## CITY OF ALLENTOWN

**R130 – 2023**

#### **Certificate of Appropriateness for work in the Historic Districts:**

## COA Final Review Sheet

**Rendering of signage in the three proposed locations of the storefront.  
(Applicant)**

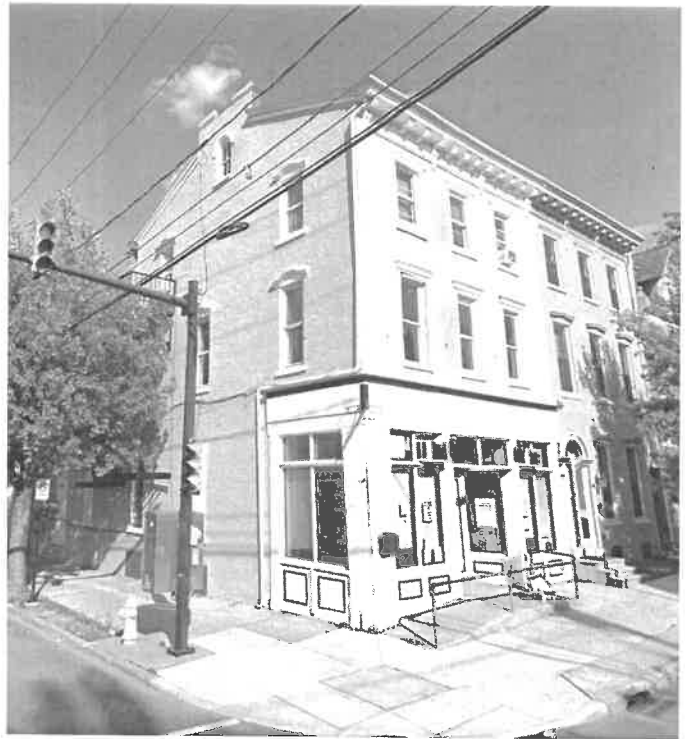
The design guidelines support the installation of surface-applied window signage with transparent backgrounds, because the signage type does not damage historic materials. Staff questions whether the sign in the transom includes an opaque background and suggests that no background color be included. Provided none of the signage includes opaque backgrounds, staff finds the application complies with the design guidelines for commercial storefronts, and more specifically with Guideline 3.13.18.

The HARB discussed the appropriateness of the proposed signage and inquired whether the sign in the transom would have a transparent or opaque background. Ms. Manzueta confirmed that the sign would have only letters and would include no background. The HARB requested that the lettering be centered across the transom and not contained on one pane of glass so that it was more symmetrical. Ms. Manzueta agreed to the request. The HARB found that the signage complies with the design guidelines.

Mr. Jordan moved to approve the application presented on 7/10/2023 for the installation of surface-applied window signage at the storefront of 347 N. 8<sup>th</sup> Street, with the staff to review details, provided the lettering is centered across both transom lites and the background is transparent, pursuant to Chapter 3, Section 3.13 Commercial Storefronts. Mr. Lichtenwalner seconded the motion, which passed with unanimous support.

**Rendering of proposed site wall.**  
**(Applicant)**

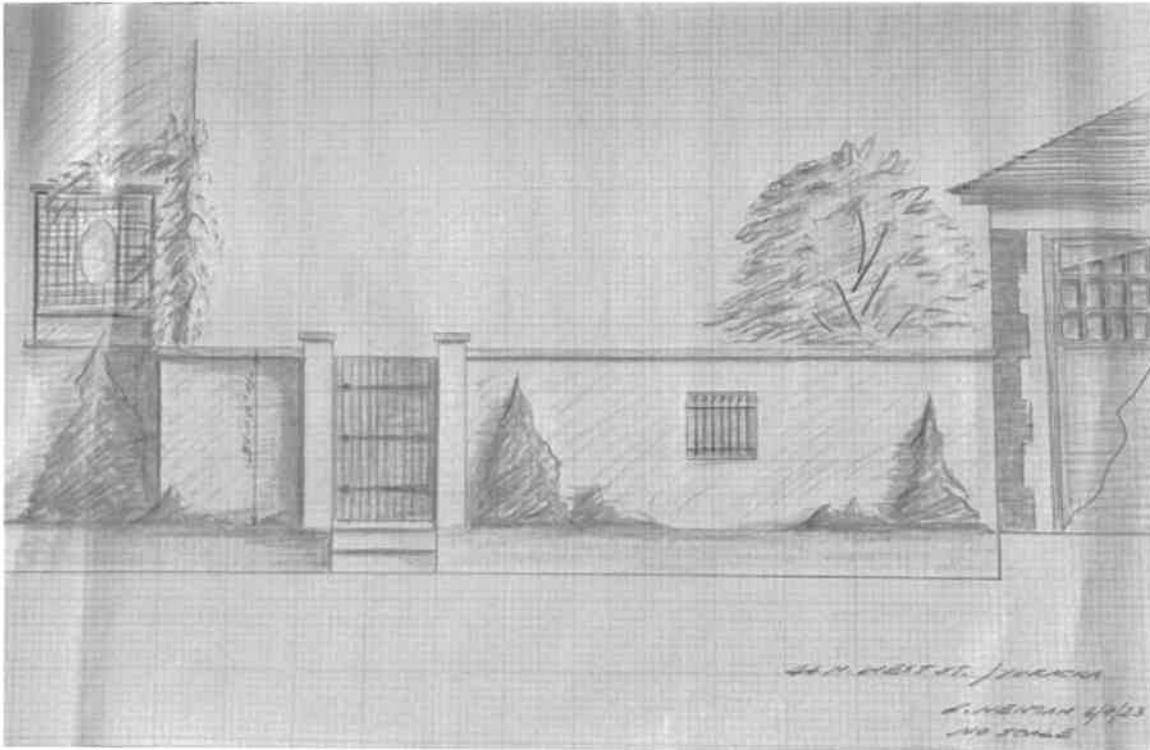
Staff finds the proposed work satisfies the intent of the design guidelines since the masonry wall would match the height of the existing fence and other nearby fences along West Street, complying with Guideline 3.12.7. The wall would be low enough, at a maximum height of 6-feet, so as not to obscure views of the building and would have no impact on the primary façade. The site wall would also comply with Guideline 3.12.12, since it would be constructed of masonry materials and finished to match the historic structure.

The proposed gate is illustrated as being wood with metal strap hinges and is appropriate in material and design.

For final approval, staff recommends that the applicant submit specs and/or cut sheets on the stucco/finish of the wall, cap, and gate.

Mr. Encelewski moved to approve the application presented on 7/10/2023 for the construction of a masonry wall in the side yard of the property at 44 N. West Street, with the staff to review details, pursuant to Chapter 3, Section 3.12 Fences & Streetscape Features and the Secretary of the Interior's Standards for Rehabilitation. Mr. Huber seconded the motion, which carried by a vote of 4-0. Mr. Hart recused.

Proposed location of signage.  
(Applicant)

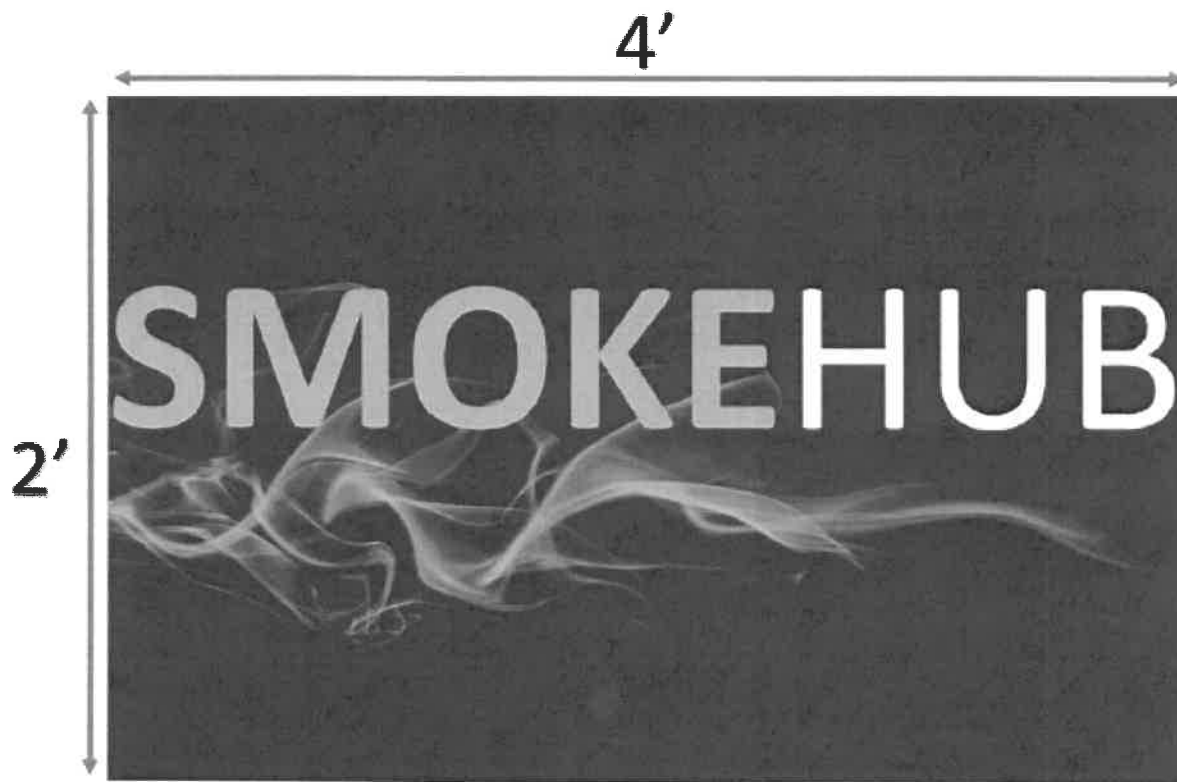
The proposed signs comply with Guidelines 3.13.12, 3.13.14, 3.13.15, and 3.13.16, because they would appropriately located above the storefront windows, would be easily reversible with no damage to historic fabric, and are of a size and scale that are appropriate for the building. However, the signs, proposed to be vinyl stickers, do not comply with Guideline 3.13.21, which recommends a high-quality and durable material. However, the guidelines do allow for surface-applied window signs with high transparency in a material similar to what is proposed. Staff recommends one of the following to comply with the design guidelines:

1. Print or paint the signs on wood or metal; or
2. Install surface-applied signs within the transom of the storefront windows.

The HARB discussed where the signage should be installed. Mr. Jordan suggested limiting the signage to the space below the former lintel. Mr. Huber stated that the signage could be installed within the upper pane of glass within the storefront window or on a wood sign above. Mr. Jordan read the staff recommendation, stating that the HARB seemed to be in agreement with the staff, but added that the sign should be centered above the storefront windows but below the former lintel. The applicant agreed to the HARB's comments and presented a revised signage plan that satisfies the design guidelines.

- Install surface-applied signs within the transom of the storefront windows; or
- Print or paint signs on wood or metal and center the sign vertically and horizontally within the space below the former lintel line between the first and second stories.
